Docket No. 50-373
Docket No. 50-374

We have received the attached Federal Emergency Management Agency (FEMA) letter dated July 1, 1985, and associated evaluation of the Alert and Notification System for LaSalle County Nuclear Generating Station in Seneca, Illinois.

The Federal Emergency Management Agency (FEMA) has completed an analysis of the prompt alert and notification system for the LaSalle Nuclear Power Station in Brookfield Township, Illinois. This review has been completed pursuant to FEMA rule 44 CFR 350; selected evaluative criteria and Appendix 3 in NUREG-0654/FEMA-REP-1, Rev. 1; and FEMA-43, the "Standard Guide for the Evaluation of Alert and Notification Systems for Nuclear Power Plants." The enclosed report entitled "LaSalle Nuclear Power Station Site-Specific Offsite Radiological Emergency Preparedness Alert and Notification System Quality Assurance Verification," summarizes the engineering design review, incorporates the results of the telephone survey of the public which was conducted immediately following the alert and notification system activation on December 4, 1984, and includes the results of the review of the other applicable evaluative criteria from NUREG

FIGURE 7

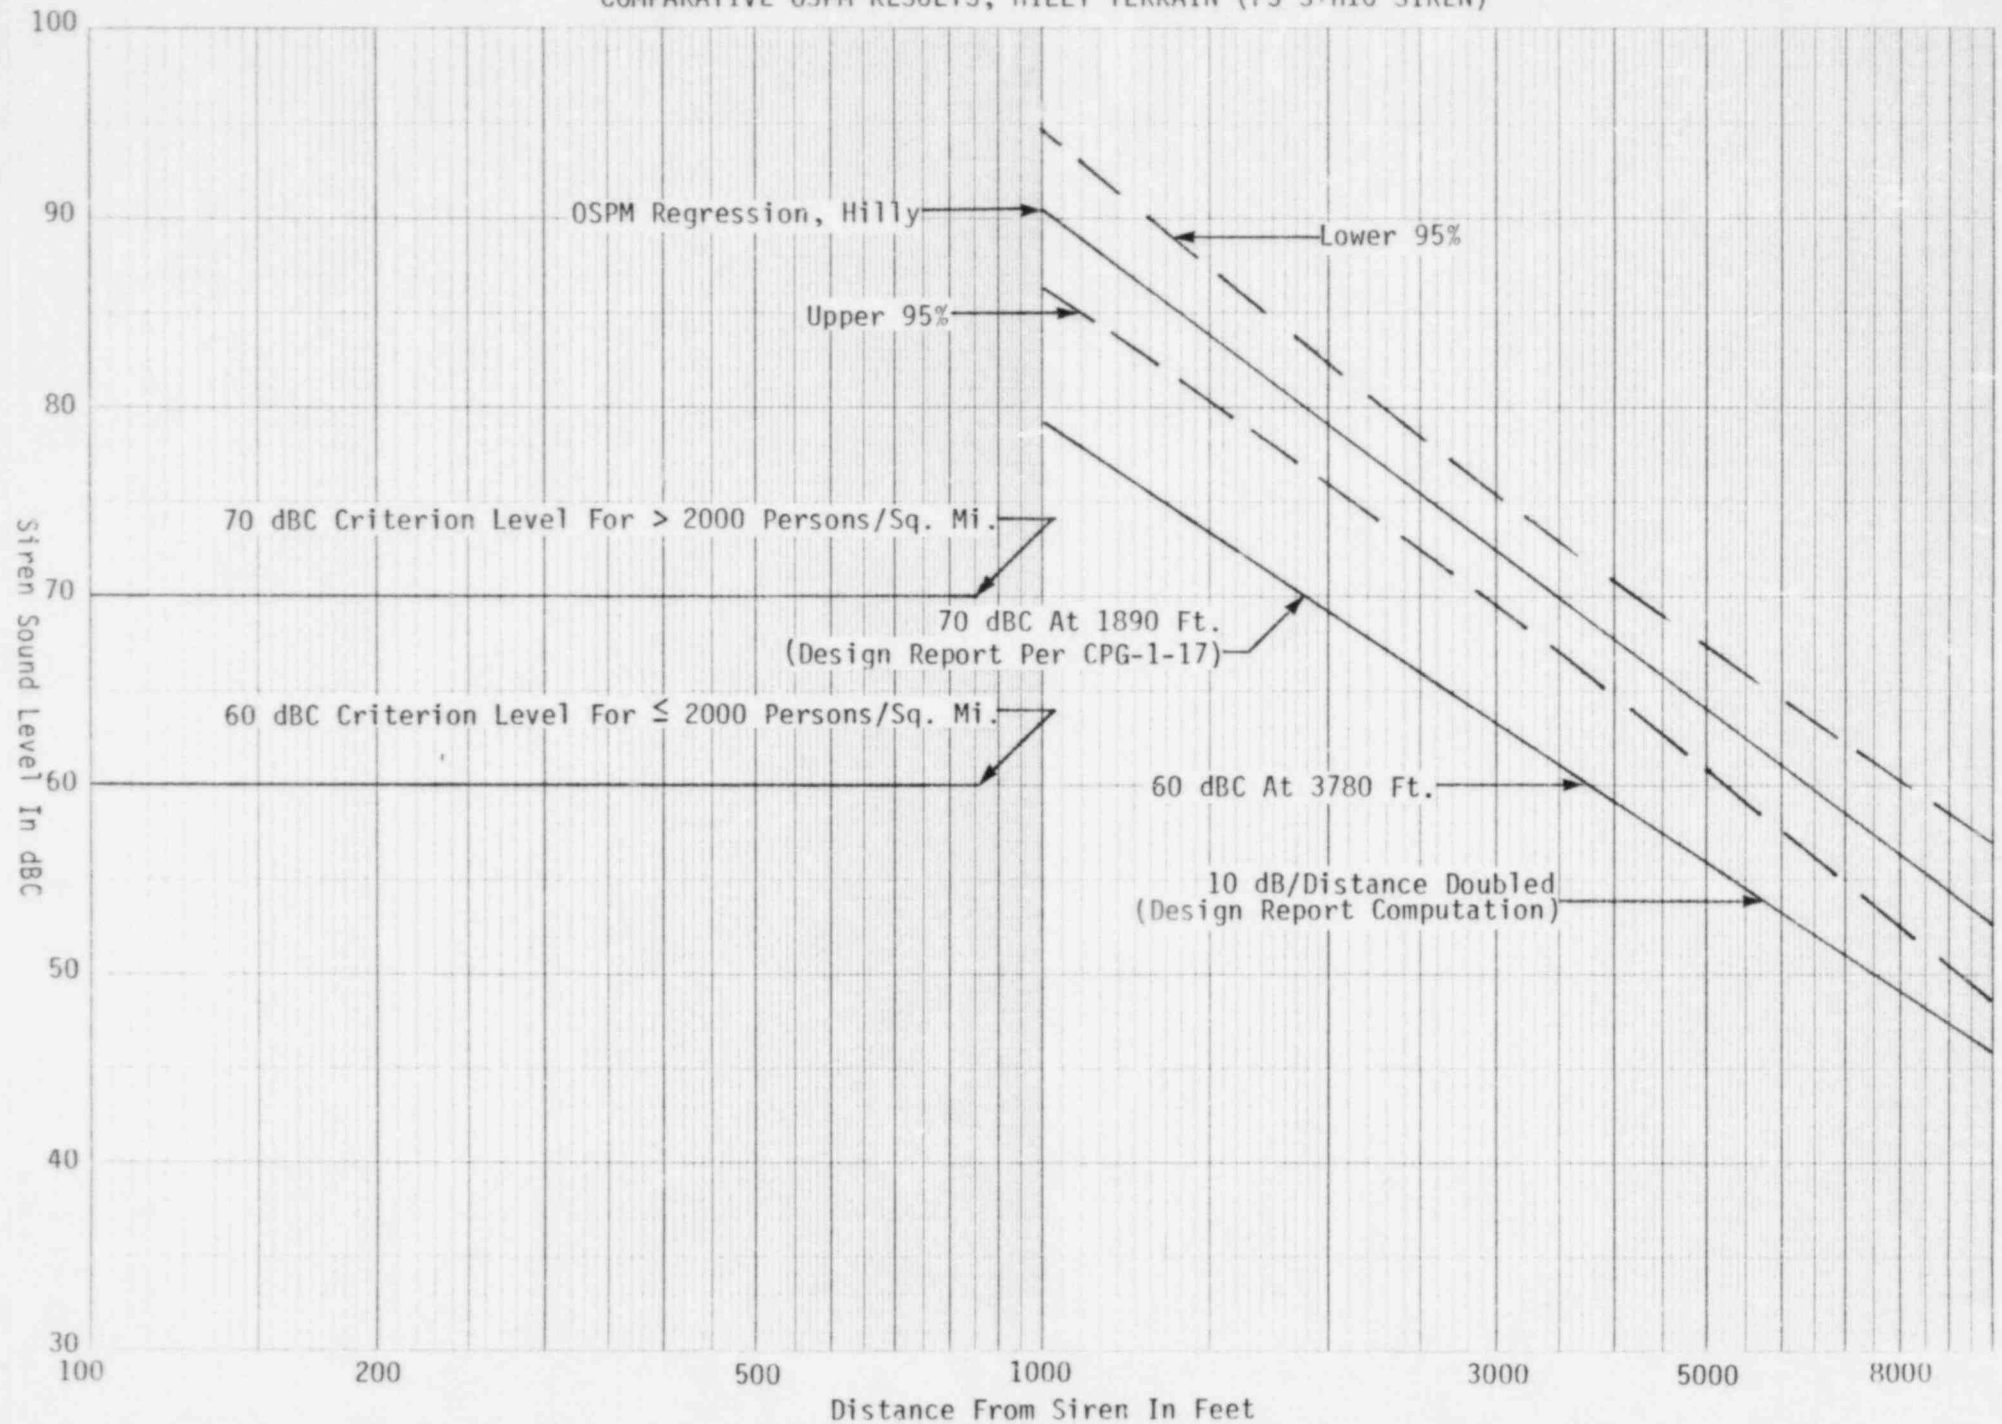
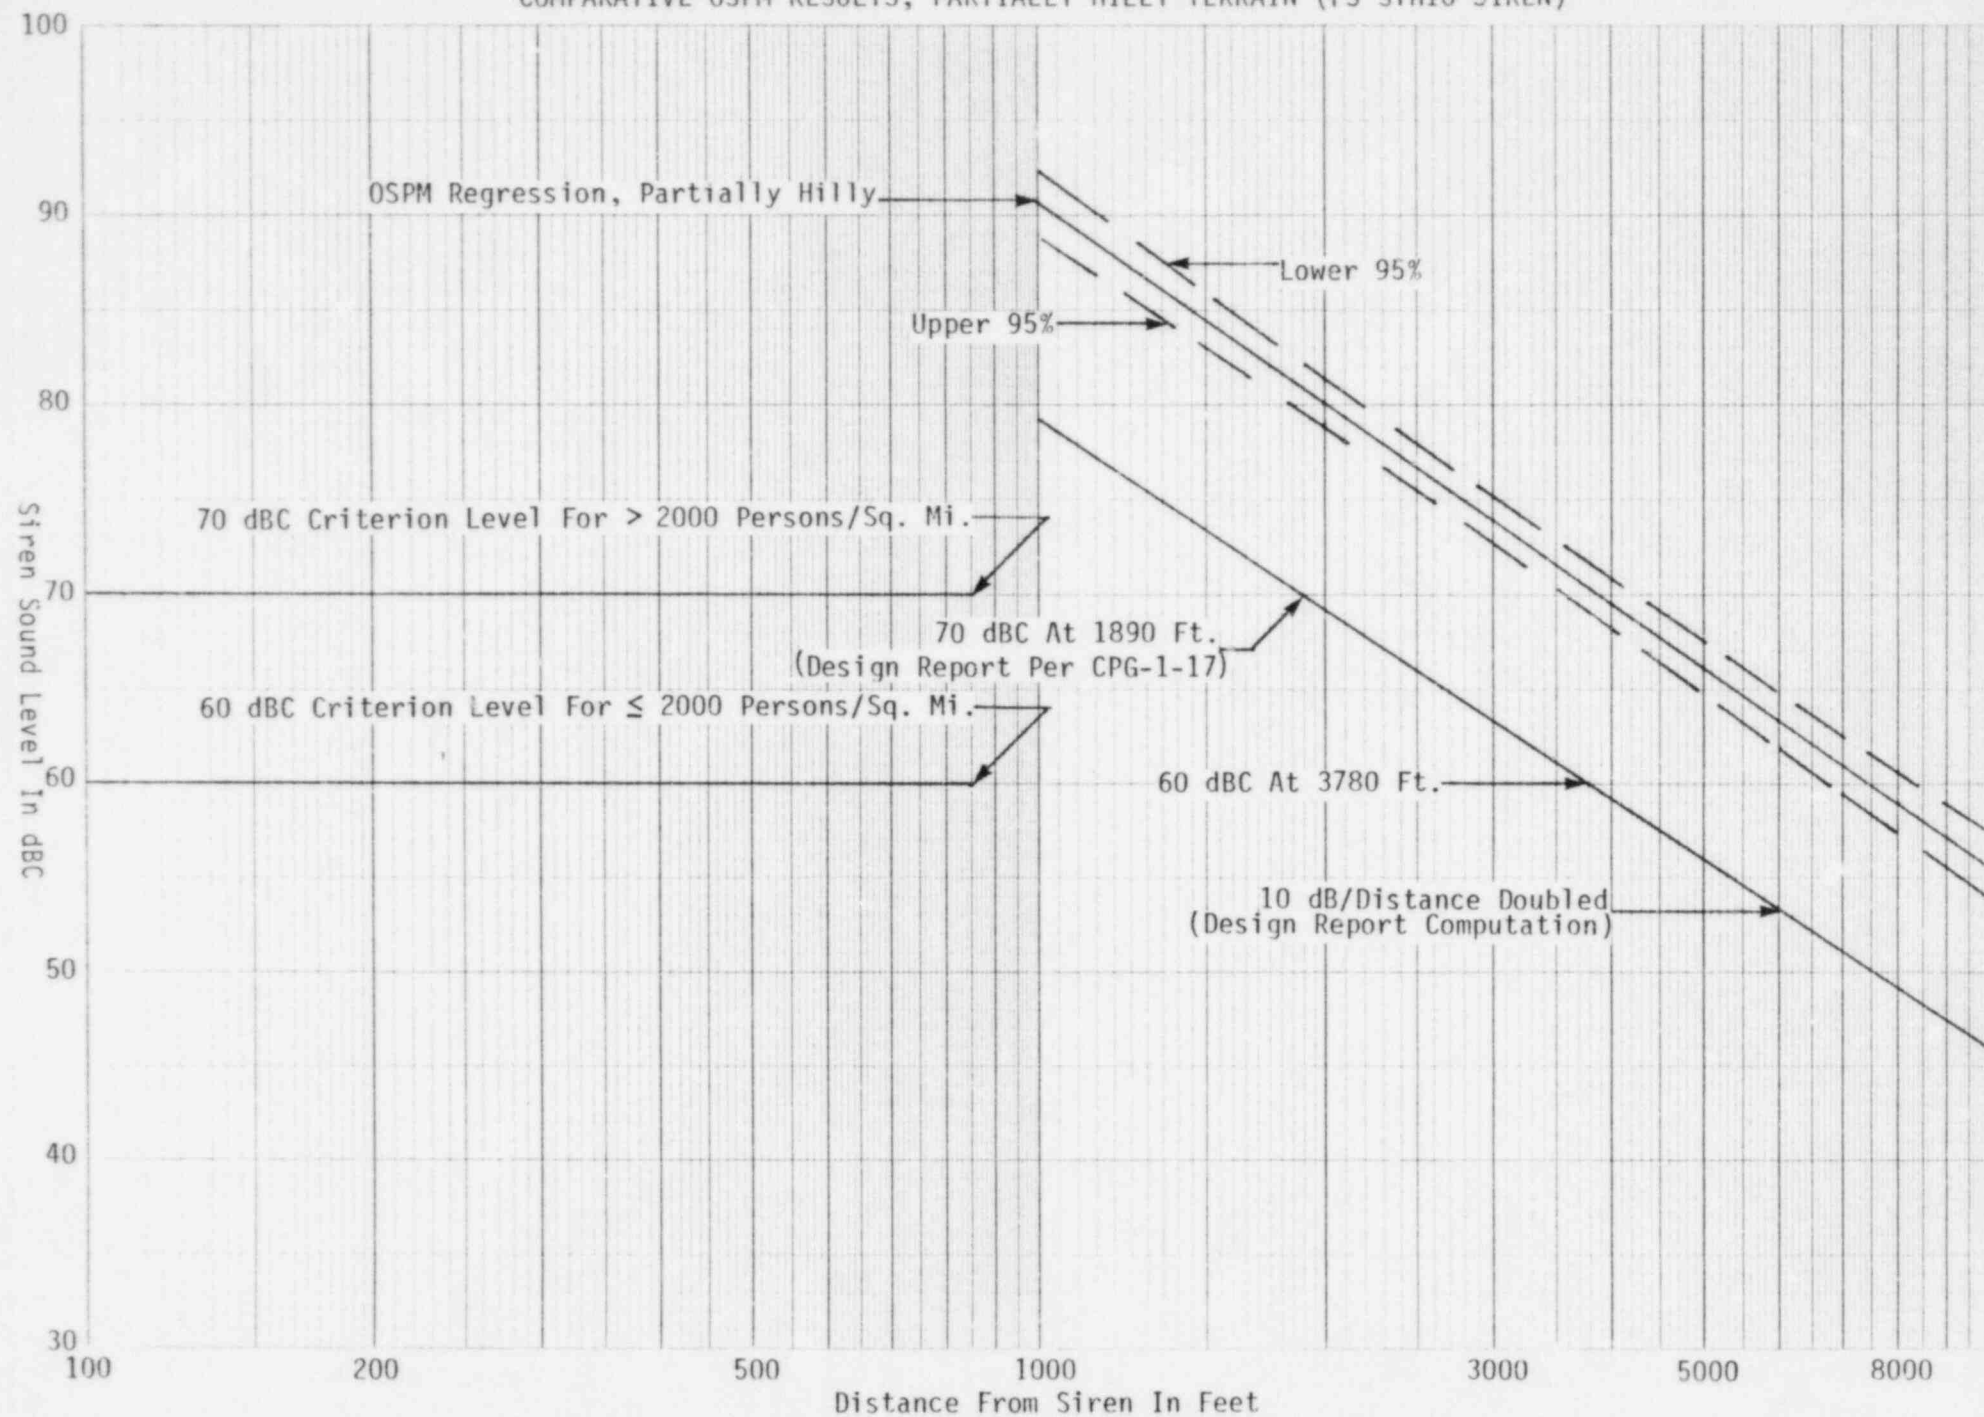
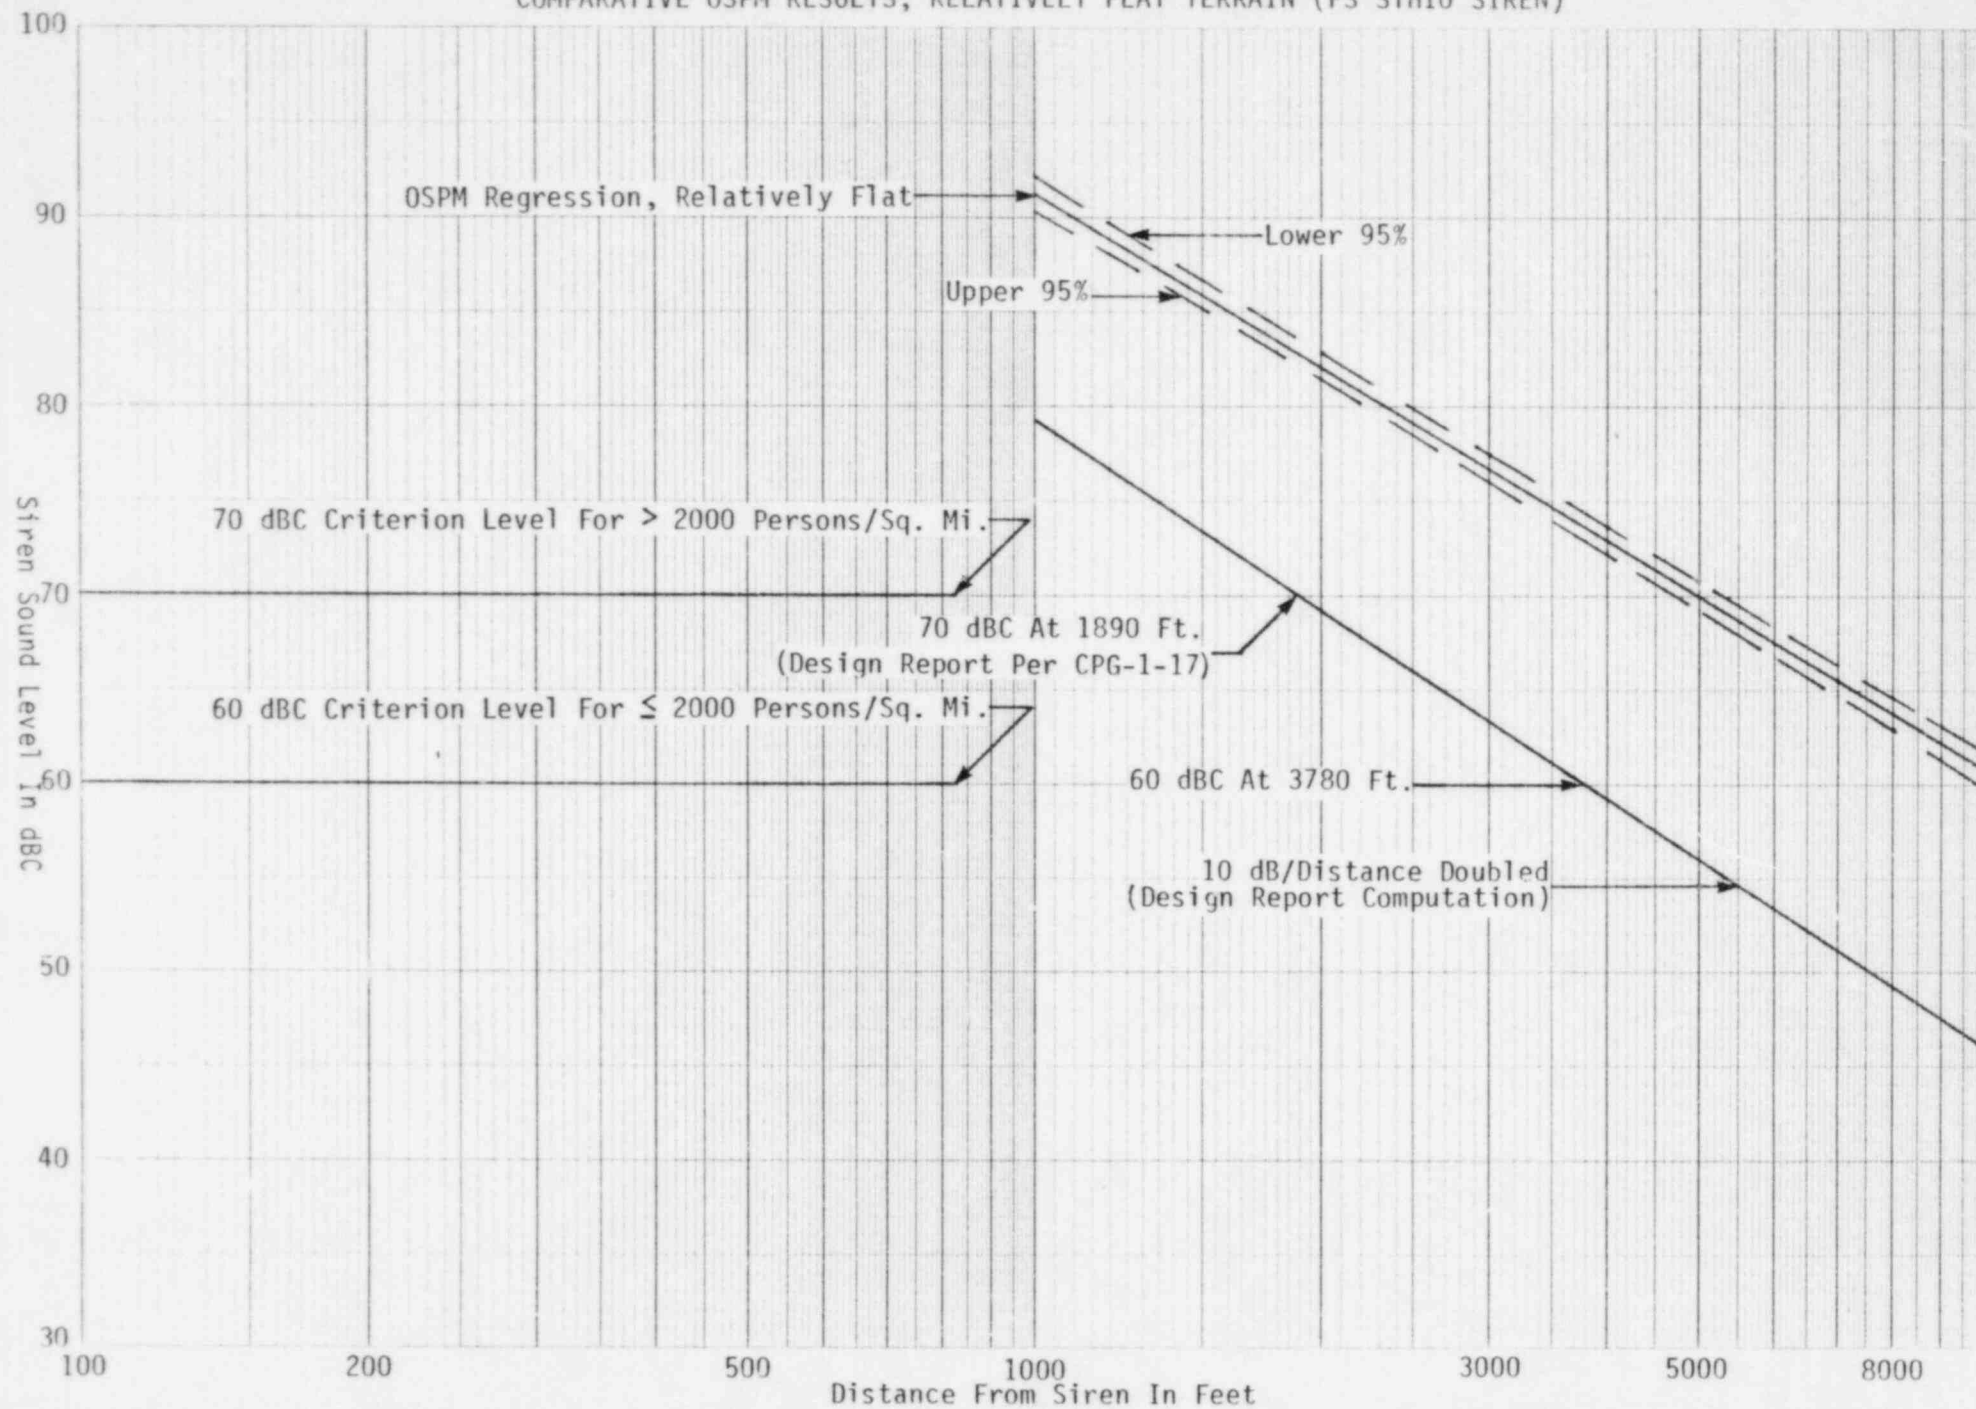
The OSPM results were classified, according to terrain profiles for each siren type, into three categories: hilly, partially hilly, and relatively flat. Regressions of dBC versus the logarithm of distance were performed for the FS 1000 and the FS STH10 sirens over each terrain category with the results depicted in Figures 3 through 8 of this report. The ranges of 70 dBC and 60 dBC as calculated in the Design Report without considering terrain barrier or two-siren additive effects are also shown on the figures and summarized below:

Siren Type	70 dBC (ft)	60 dBC (ft)
FS 1000	5700	11,400
FS STH10	1890	3780
FS Model 2	690	1380
FS LCS	-	740

These ranges are conservative over relatively flat terrains, with the conservatism being pronounced for the 70 dBC range estimates. In addition, the range estimates that include the barrier attenuation procedure over partially hilly and hilly terrains adequately account for the site terrain characteristics.
